ANDERSON'S CAJUN'S WHARF  
(Official Project Name)

- MA 81983-6105-04:
- EXTENDING THE ASPHALT PARKING LOT, ADDITION OF DECK THAT WILL TIE INTO EXISTING DECK, ADDITION OF STAIRWAY TO PROPOSED DECK.
  - RECONSTRUCTING THE STAIR ENTRY TO THE EXISTING DECK, RECONSTRUCTING THE STAIR ENTRY AT THE SOUTHWEST CORNER OF THE BUILDING, MODIFICATIONS TO THE FRONT ENTRY, ADDING A CONCRETE WALKWAY AND STAIRS TO THE ENTRY AND ADDING AN OVERHANG, REMOVING 4 PARKING SPOTS AND REPLACING THE SIDEWALK, CURB, & GUTTER.
  - RECONSTRUCTING THE ADA LANDING, AND ADDING A PEDESTRIAN CURB RAMP, ADDING SIGNAGE TO BUILDING.
  - ADDITION OF WALL AROUND POND TO INCREASE CAPACITY TO ACCOUNT FOR THE ADDITIONAL IMPERVIOUS AREA.
  - REVISING LANDSCAPE PLAN.

**WATERPARK SUBDIVISION FILING #2 MNOR  
SITE PLAN AMENDMENT**  
2430 S. HAVANA ST.  
AURORA, CO. 80014

MINOR SITE PLAN  
AMENDMENT

SHEET NUMBER  
A1.1

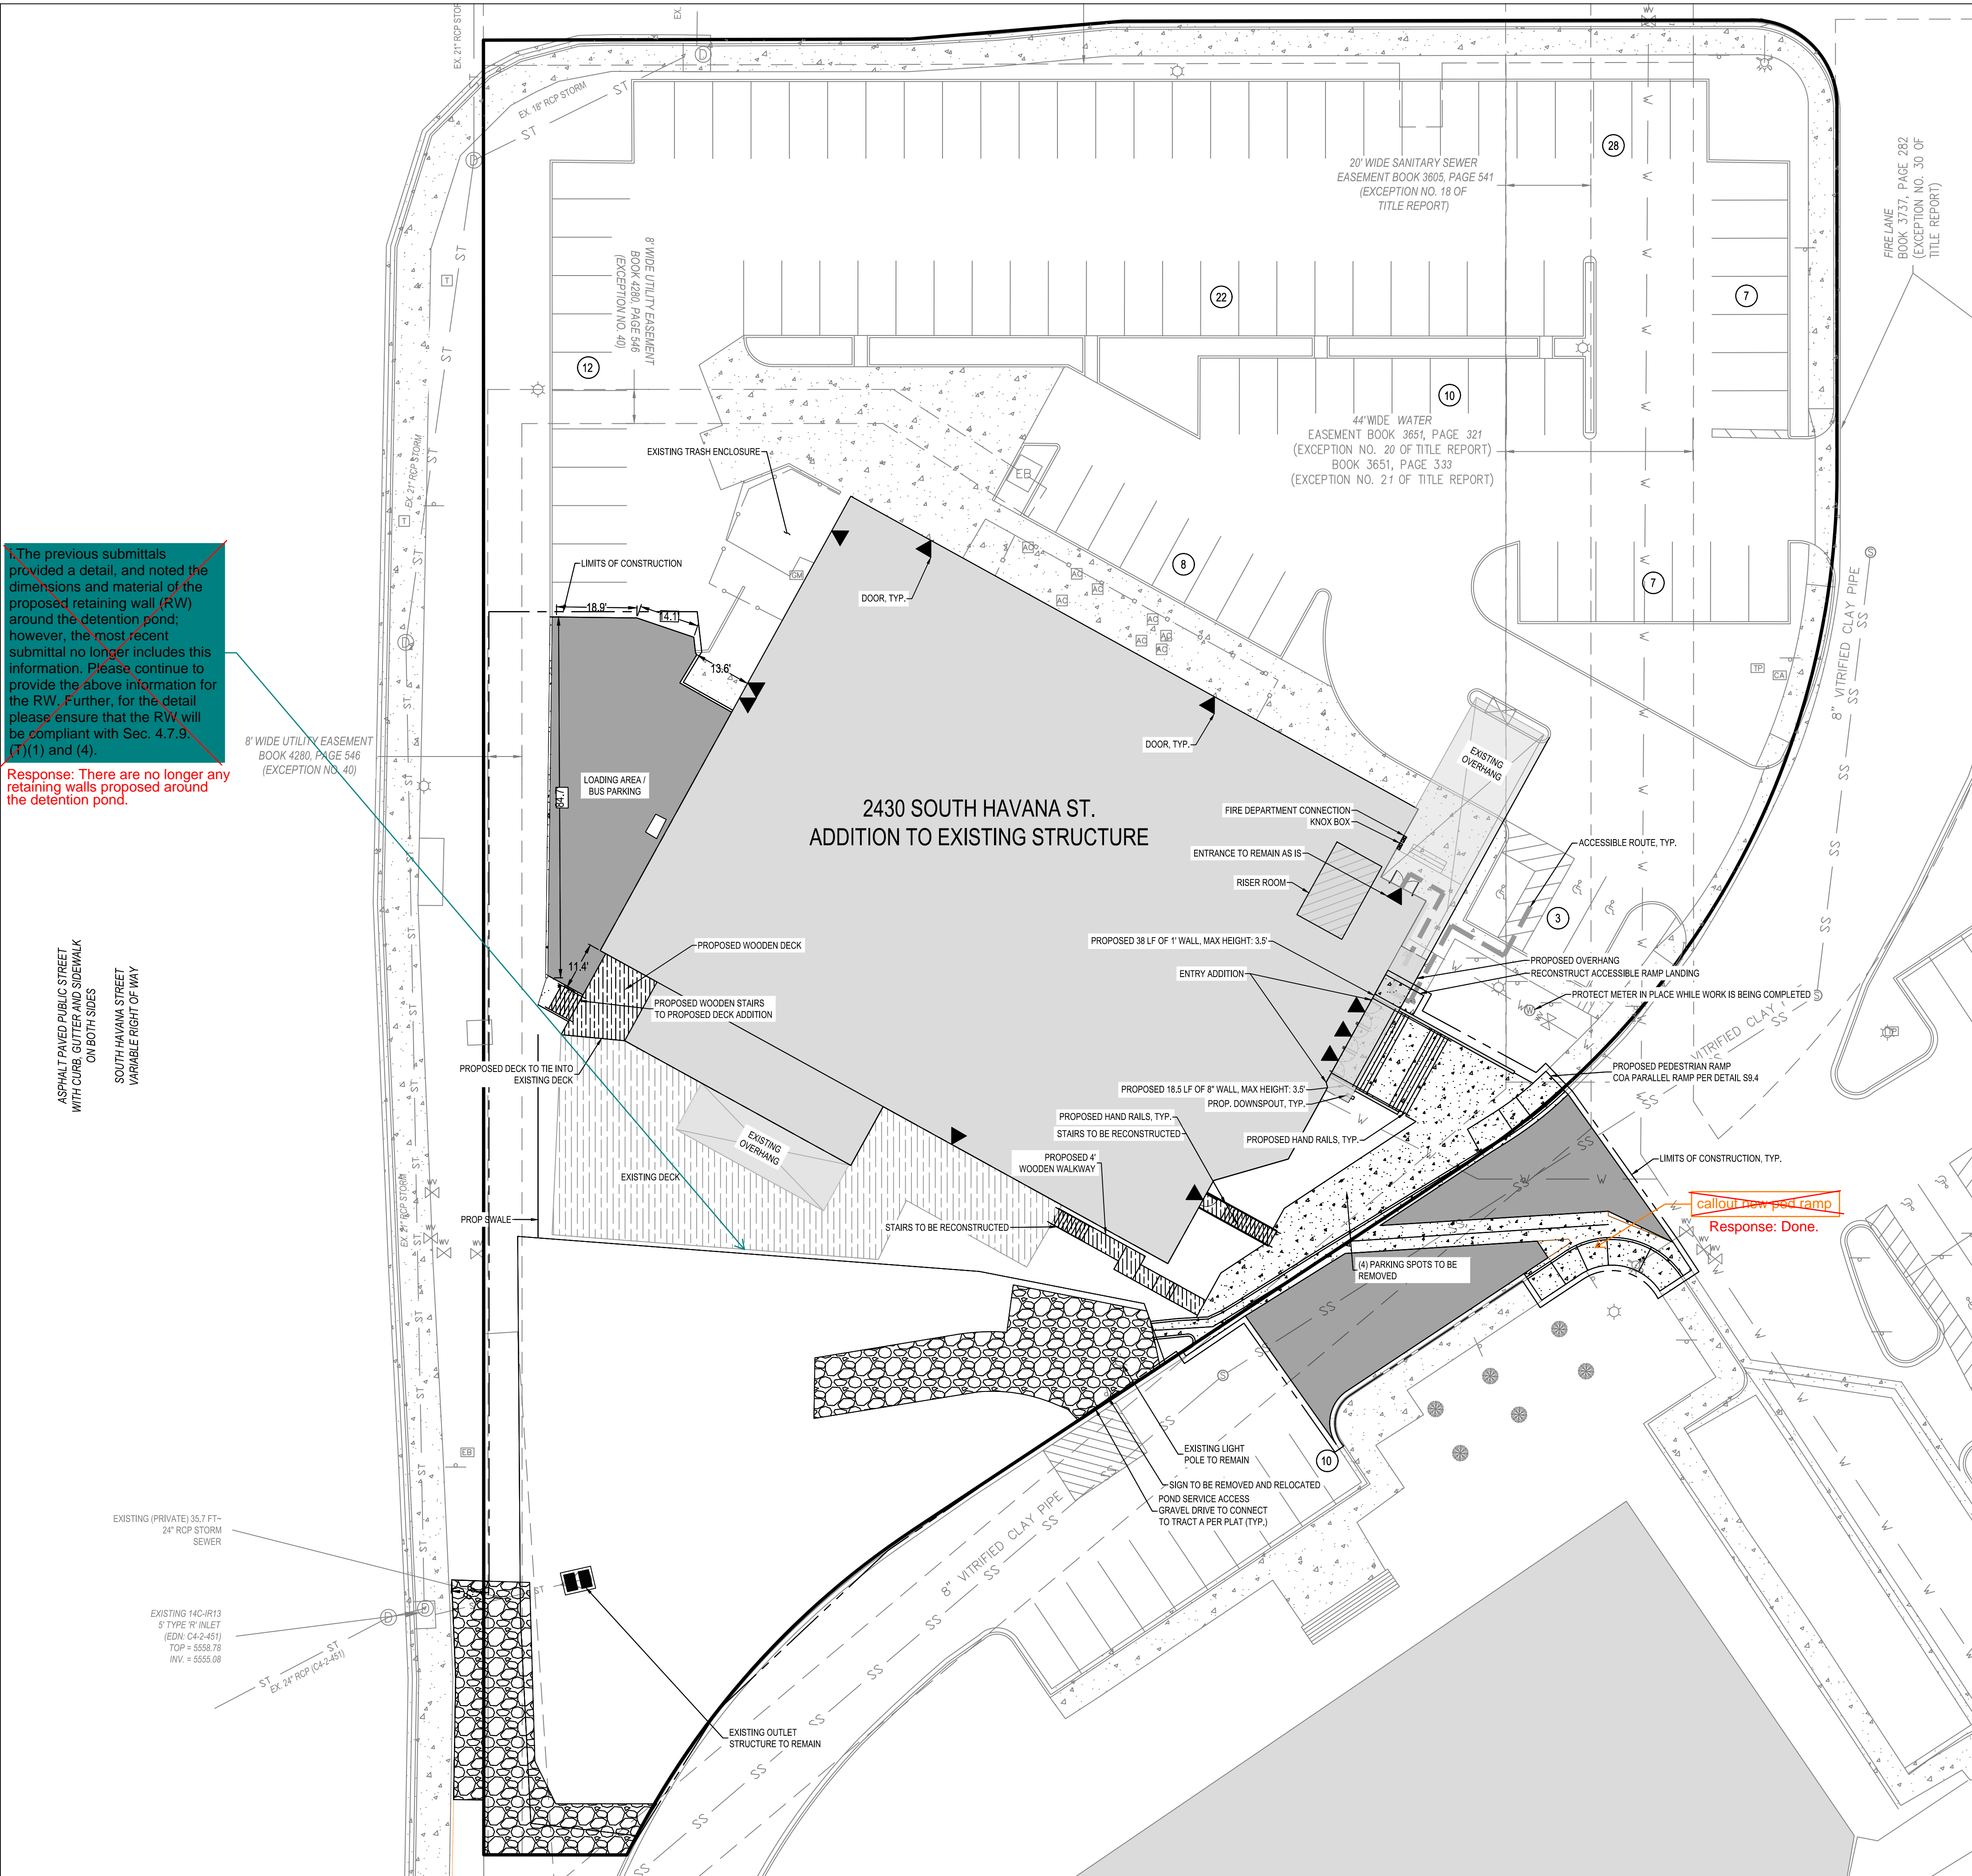
Advisory note: Please provide existing civil plans if no existing civil plans are available then a new civil plan set will be required

Please proceed with civil plan submission. The civil plan submission needs to be in process prior to approval of the site plan

PROPOSED LANDSCAPING TO BE REVISED PER SHEETS L1.1 - L1.3

Response: Civil plans have been approved (EDN 1983-6105-04)

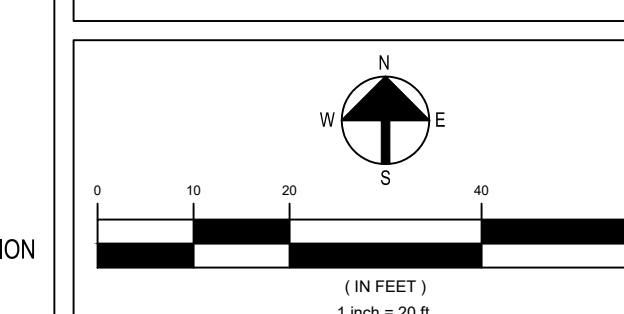
callout new ped ramp  
Response: Done.

SHEET 4 OF 14

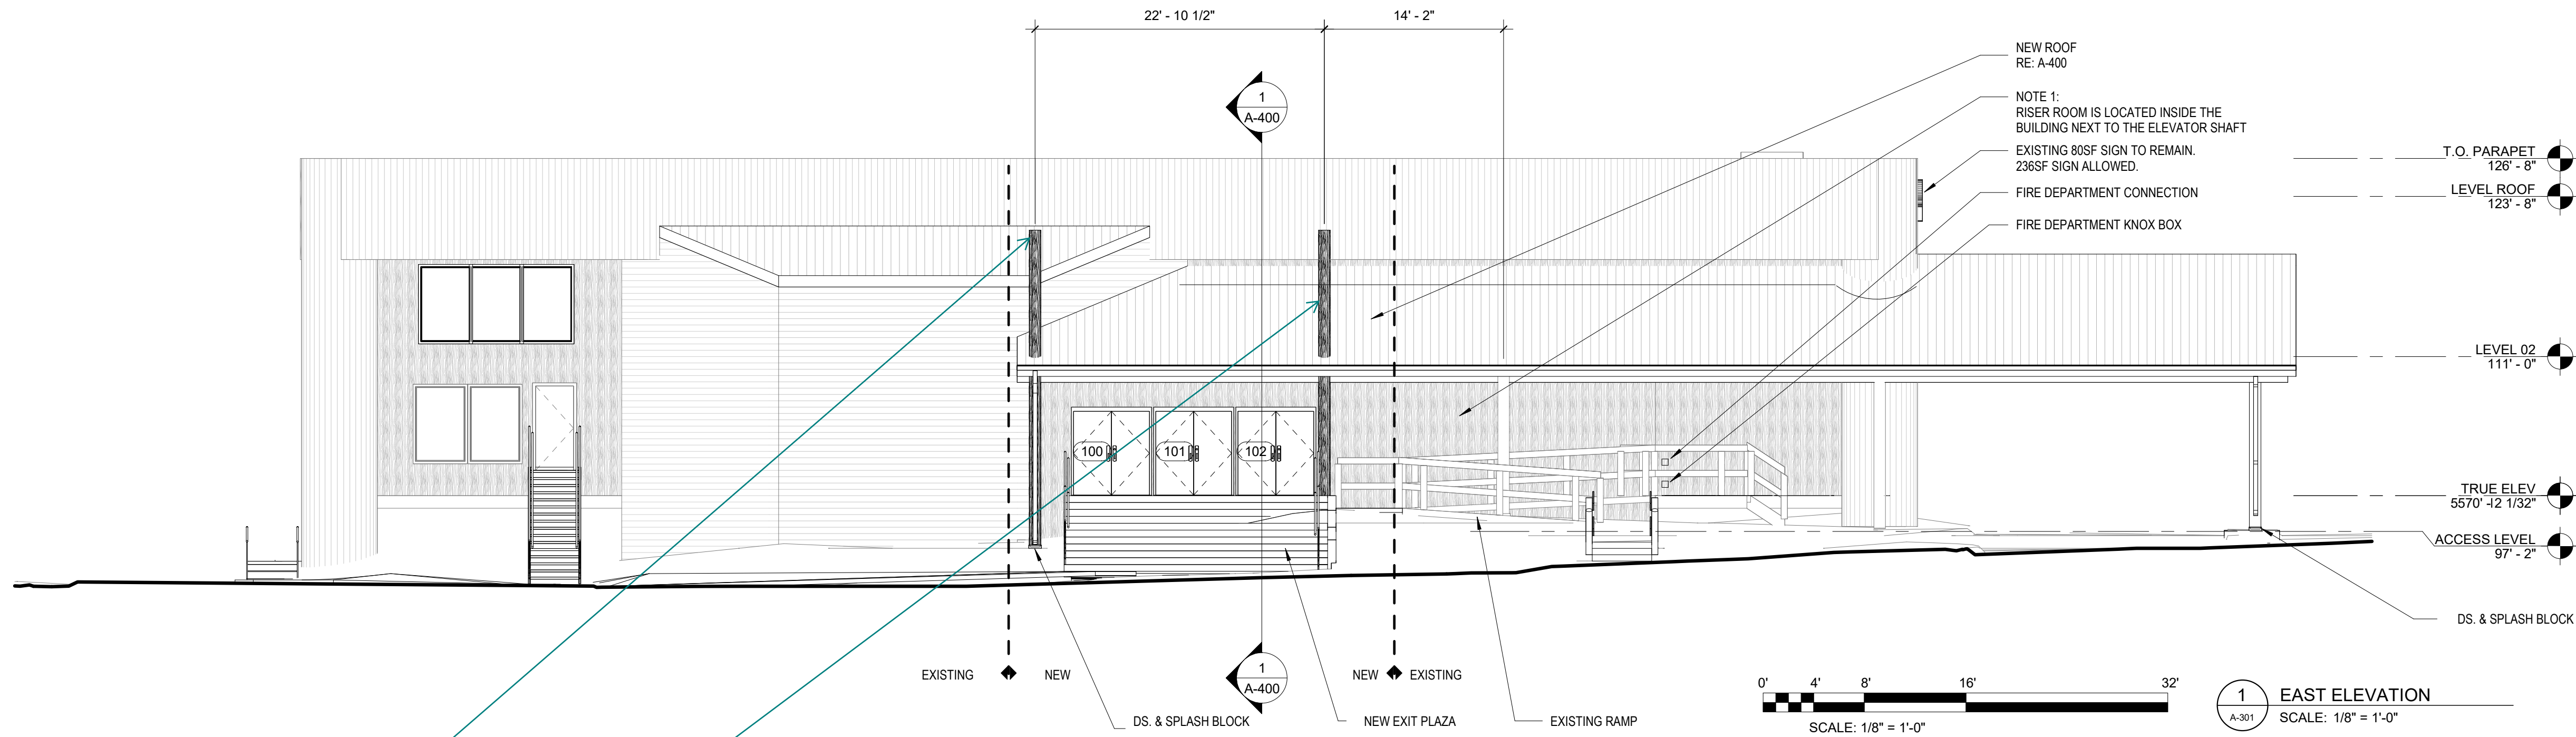
It appears that this is a duplicate page. Please only keep page 4 or 14.

Duplicate removed.

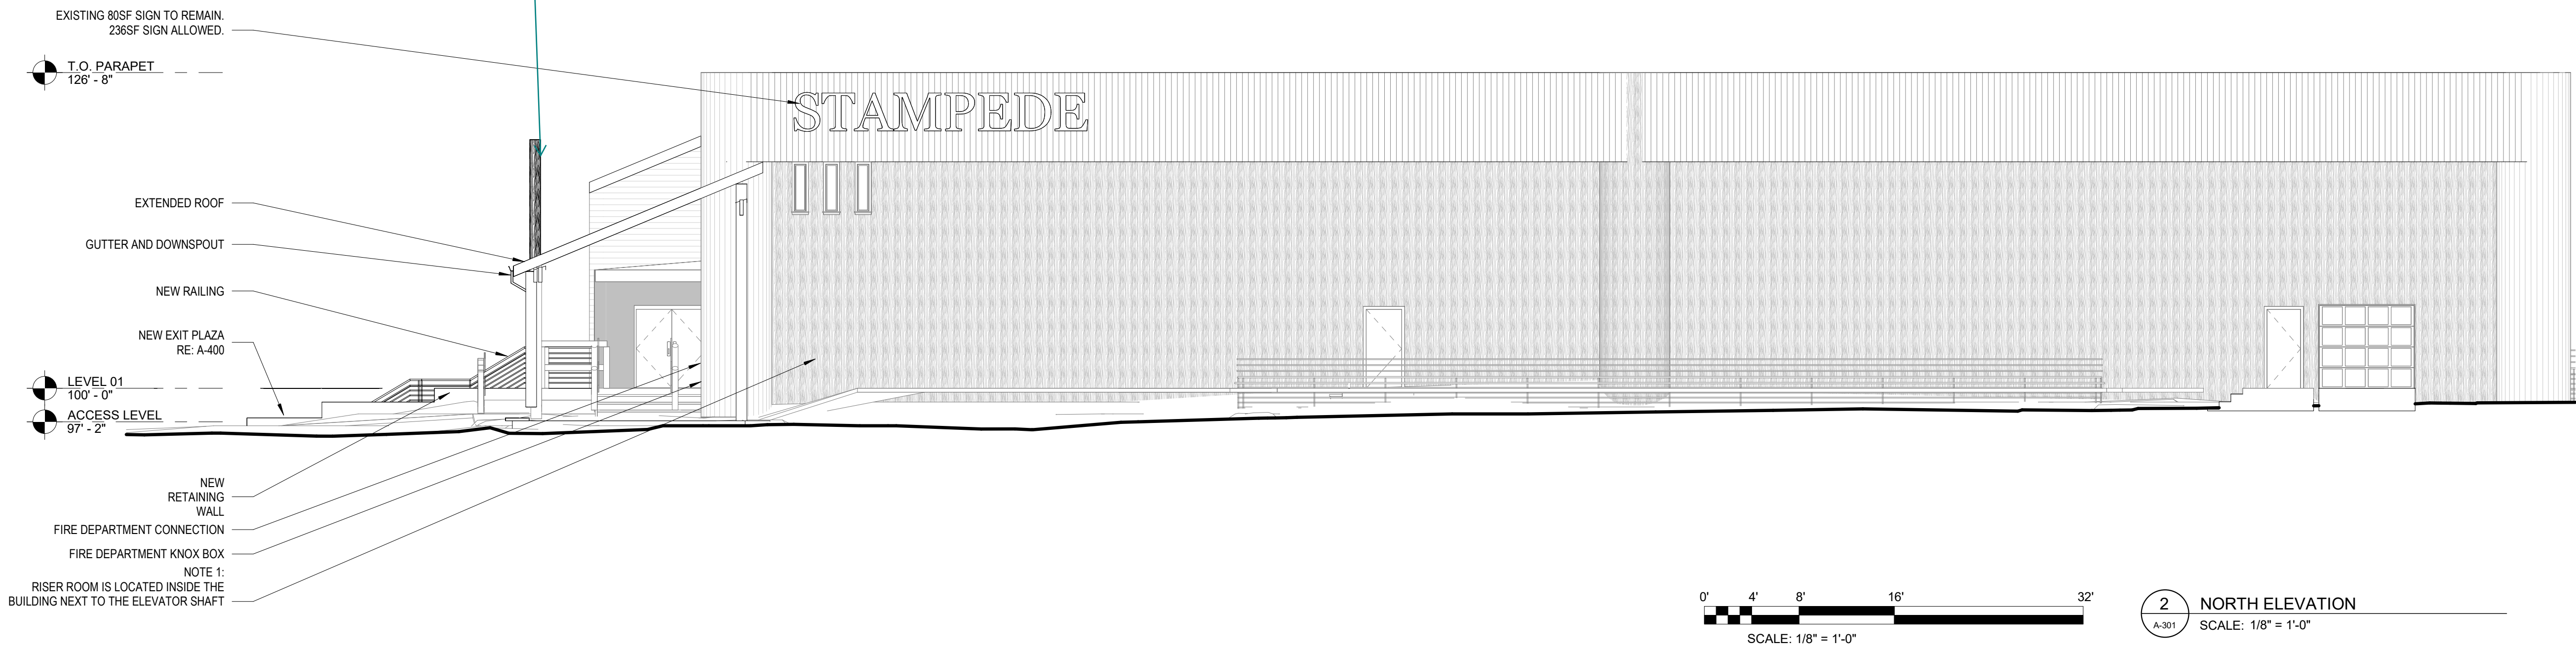
Will these posts remain or be removed as the sign is no longer being pursued?

Yes, posts will remain

A-301

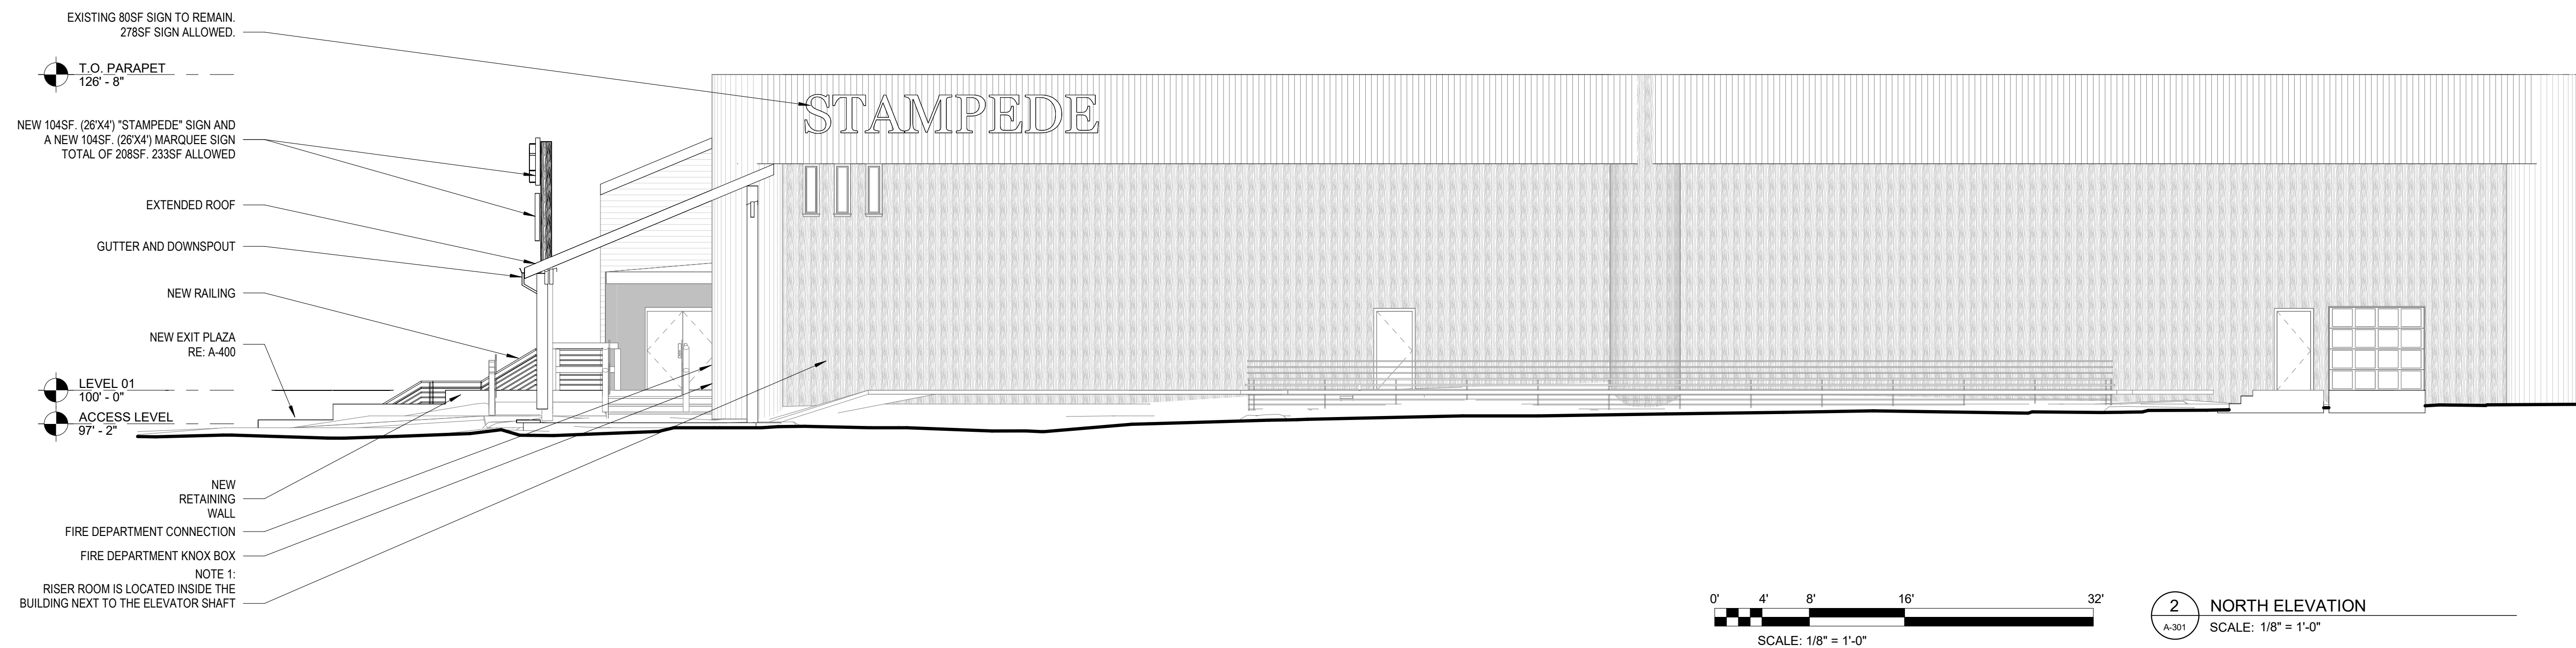
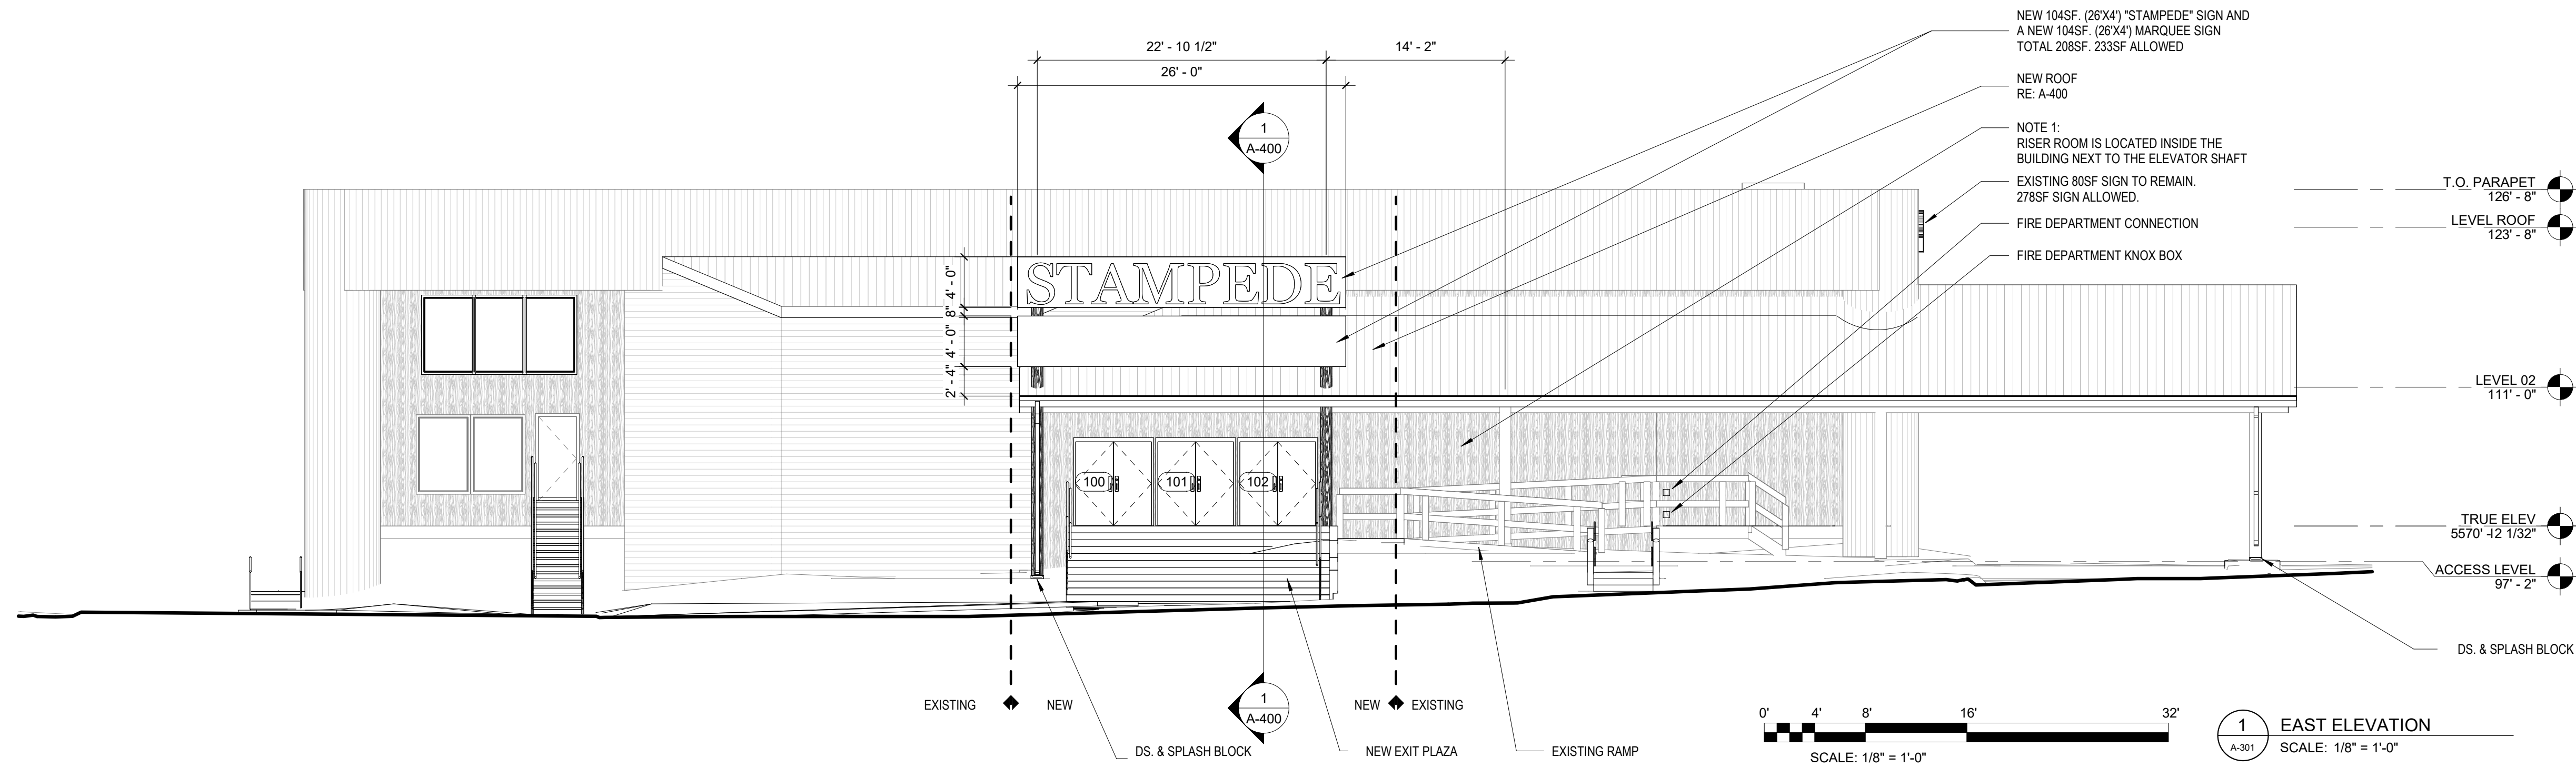
Please remove this sheet.
